TOWN OF YORKTOWN PLANNING BOARD

PUBLIC MEETING AGENDA YORKTOWN TOWN HALL BOARD ROOM 363 Underhill Avenue, Yorktown Heights, NY 10598

**December 12, 2022
7:00 PM**

PROPOSED IMPROVEMENTS PLAN WITH STORMWATER FEATURES

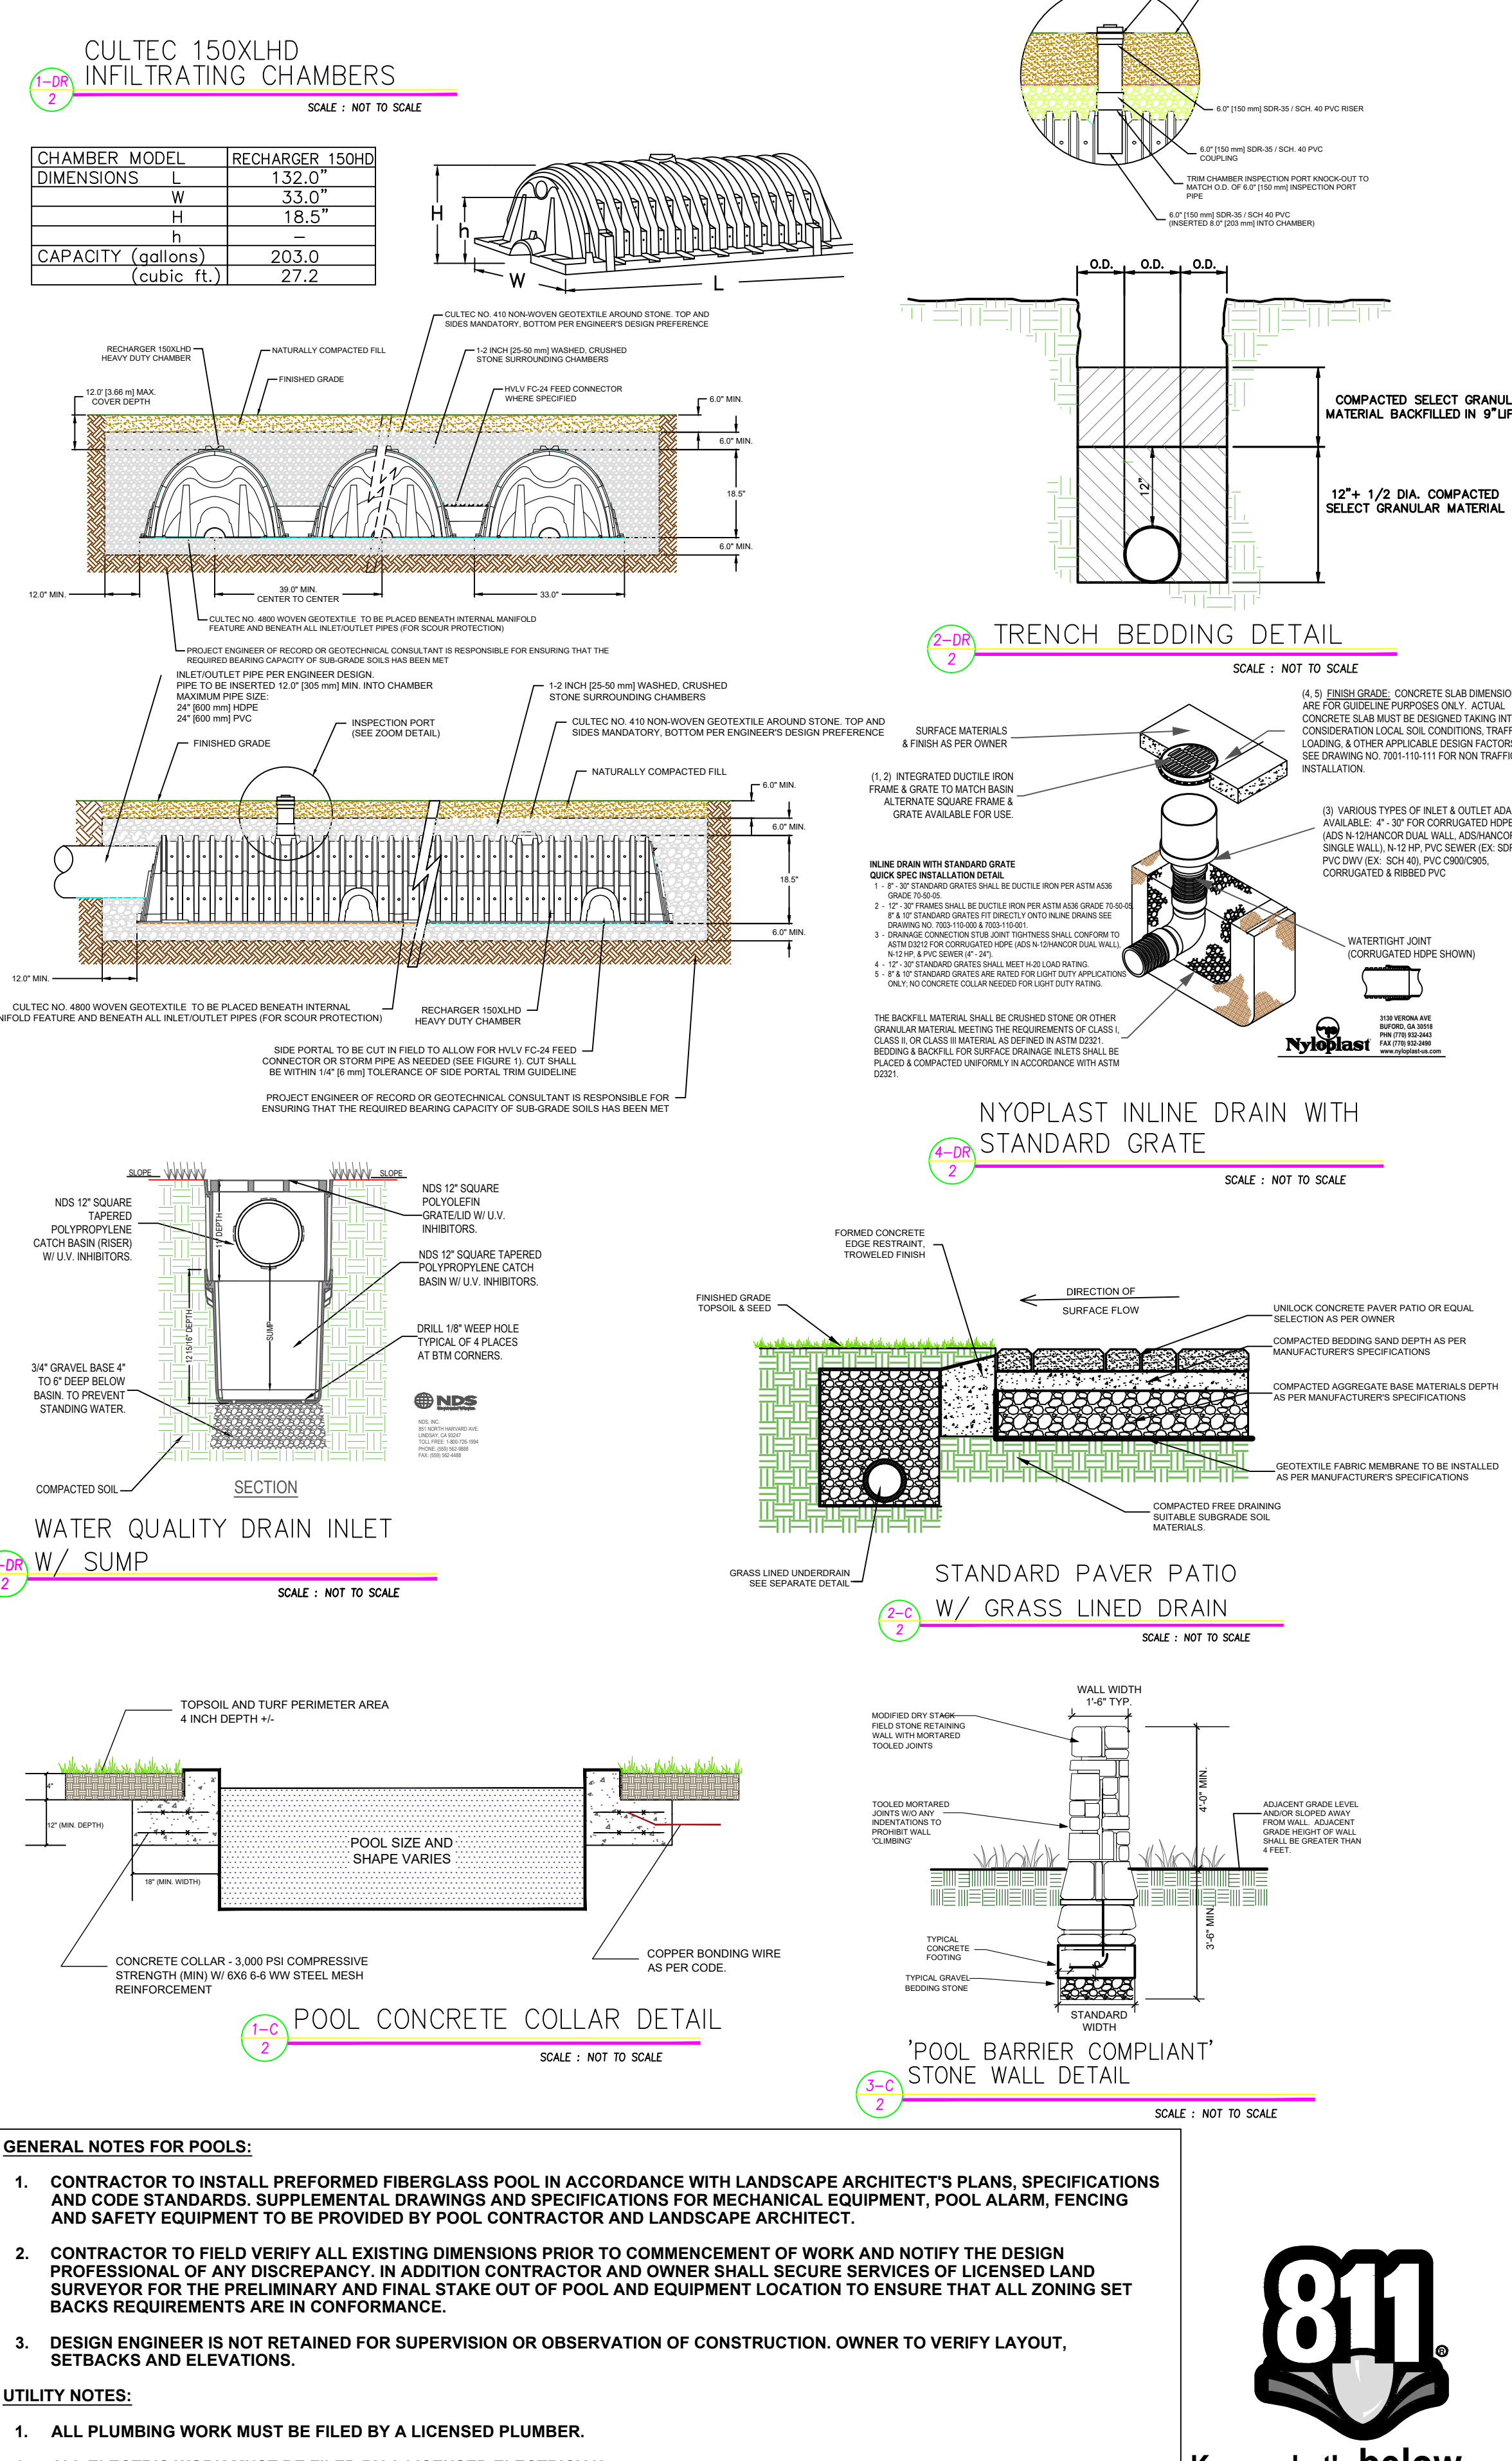
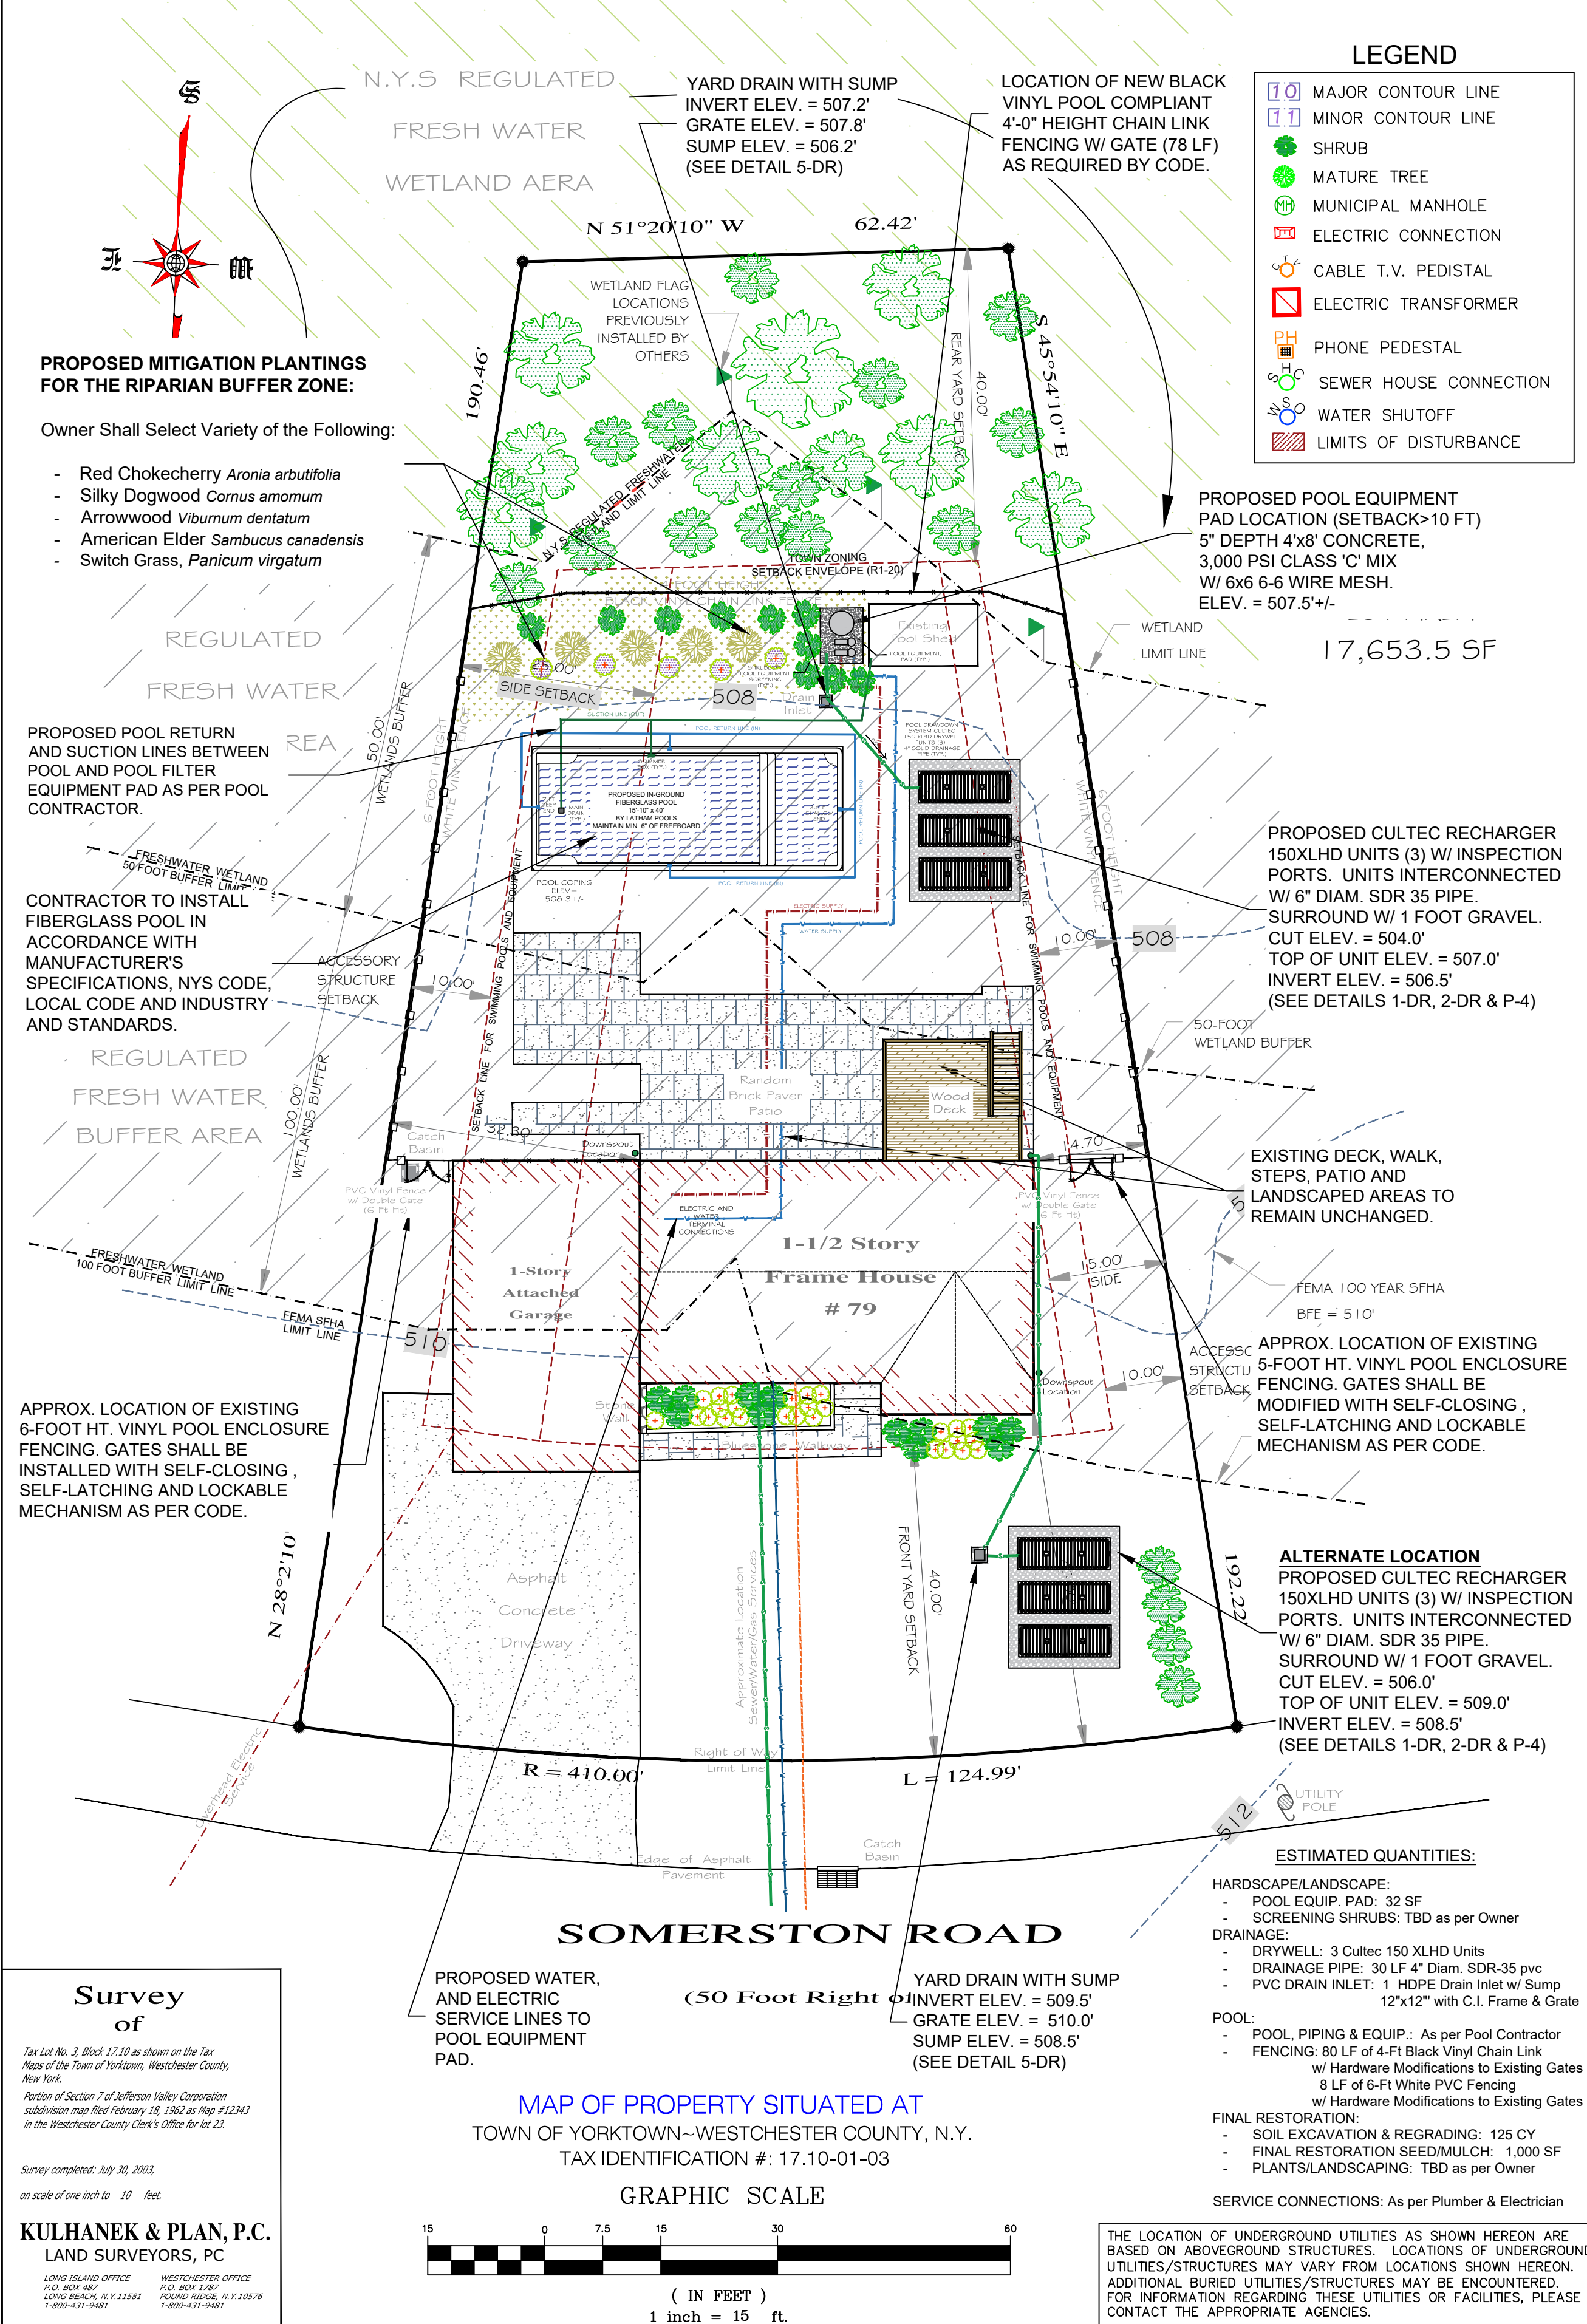
At its meeting on November 28, 2022, the Planning Board discussed the subject application. The Board was unclear if the new garage addition was already approved, since it was not shown on the existing conditions plan, but is shown on the development plans and is not part of this application. The entire proposed development is within the 100 foot buffer from a state wetland, a town wetland, and is in the flood plain. The Board questioned if soil testing had been completed since the application is showing infiltration within a flood zone. More information is required and a representative is requested to be present for the Board to evaluate the cumulative effects of the proposed project.

- D. **Stormwater Management Design:** In keeping with Town code, a conceptual plan to mitigate surface water runoff from increased impervious coverages coupled with seasonal pool drawdown is developed and provided on page 2 of the attached plans. While the project calls for a net increase in impervious coverage of 76 square feet, a design including shallow infiltration units will be sized for full pool coverage for the standard 25-year, 24-hour rain event in conjunction with percolation rates which will be field determined at a later date. Modeling as such is consistent with New York State Department of Conservation's design standards for stormwater management. The primary location for the drainage system is in the rear yard. However should field investigations determine that the front yard is more suitable than the rear, that location will be used.
